CONGRUENT SOFTWARE, INC.
3998 Whittle Avenue
Oakland, CA 94602
(510) 531-5472
(510) 531-5472 FAX

FROM: Peter Johansson
 TO: T10 SBP-2 *ad hoc* Working Group
 DATE: July 22, 1997
 RE: SBP-2 Management ORB Time-outs

This memorandum proposes a change to the definition of the MANAGEMENT_AGENT register that removes the requirement for time-outs on any of the SBP-2 management requests. As defined below, the initiator may poll the contents of the register to determine whether or not a particular request is in progress.

Figure 1 – MANAGEMENT_AGENT format

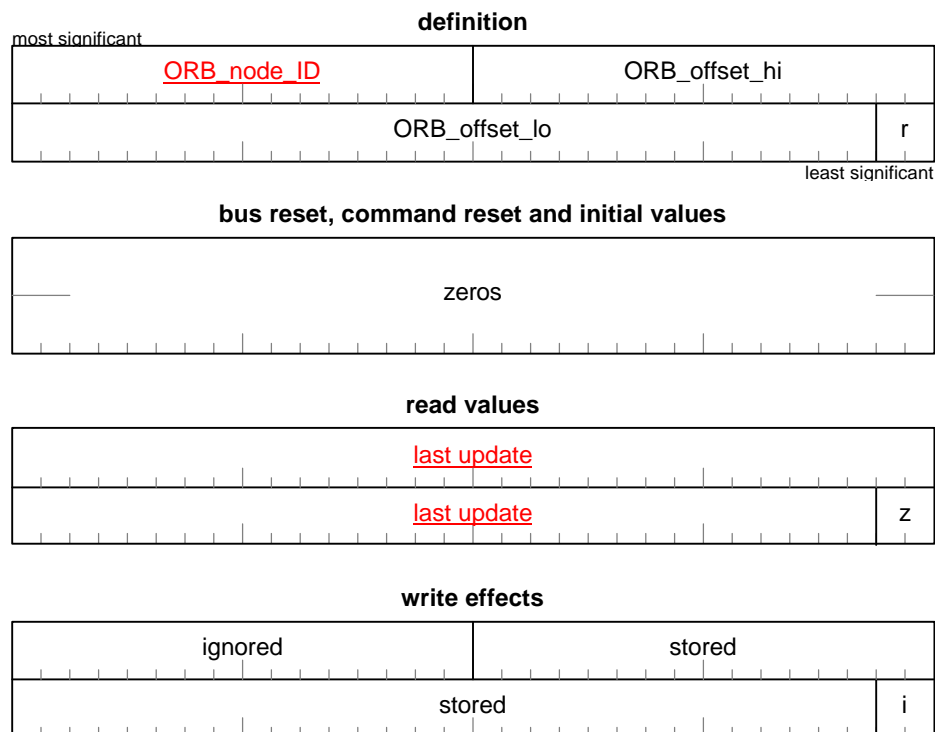
When the target is busy with a management request, the ORB node ID field shall contain the 16 most significant bits of the Serial Bus address used in the fetch of the management ORB. The target shall update this field from the source ID field of a successful block write addressed to the MANAGEMENT_AGENT register.

The ORB_offset_hi and ORB_offset_lo fields together form an ORB_offset field from which a Serial Bus address is derived ~~when in order to fetch~~ the management ORB ~~is fetched~~. The Serial Bus address shall be formed from the concatenation of ORB node ID~~the 16-bit node ID of the initiator (available to the target as the source_ID field of the block write request that updated the register)~~, the ORB_offset field and two least significant bits of zero.
